**ANNEXURES TO MEMORANDUM OF PLANNING MATTERS FOR AUCKLAND  
COUNCIL - Waitakere Courthouse Project**

**Dated: 22 January 2026**

## Technical Specialist Memo – Healthy Waters and Flood Resilience

Waitākere District Court – New Courthouse Project

### Waitākere District Court Flooding Evacuation Plan - During Event (Peak Flooding Level)

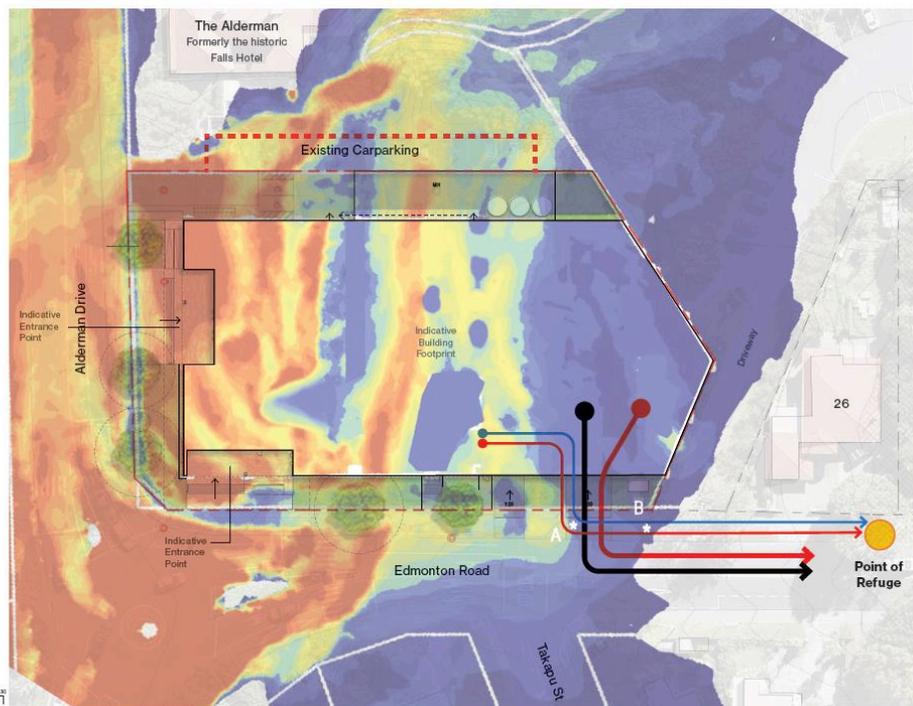
The Plan suggests notable differences to the risk categories that are shown on Auckland Council’s GeoMaps viewer, which have been used as the basis of the PC120 assessments that have been provided by the Applicant’s Agent and Engineers. The key areas of notable difference are the categorisation of risk at the pedestrian access to the building on both Alderman Drive and Edmonton Road, as well as safe egress and refuge areas.

Where site specific flood modelling has been undertaken, it is considered more appropriate to use this as the basis for PC120 categorisation and assessment, rather than the hazard classifications presented indicatively on GeoMaps.

It is acknowledged that revision of this information will not likely materially affect the outcomes of the PC120 assessments that have been provided however would likely assist the panel in clearly understanding the flood hazards in undertaking their assessment against the relevant objectives and policies of Chapter E36 (PC120).

HWFR recommend that the comprehensive information and modelling undertaken and presented in the response dated 19 December 2025 is utilised to apply and delineate the PC120 Flood Hazard Risk Ratings. The PC120 assessments would then ideally be updated in reference to this confirmed hazard classification (based on site specific modelling) instead of the indicative hazard classifications that are shown on Auckland Council’s GeoMaps viewer. Importantly, and to assist the Panel, we do not anticipate the use of site specific modelling information to achieve this classification will result in a different recommendation on the proposal as provided in the memorandum.
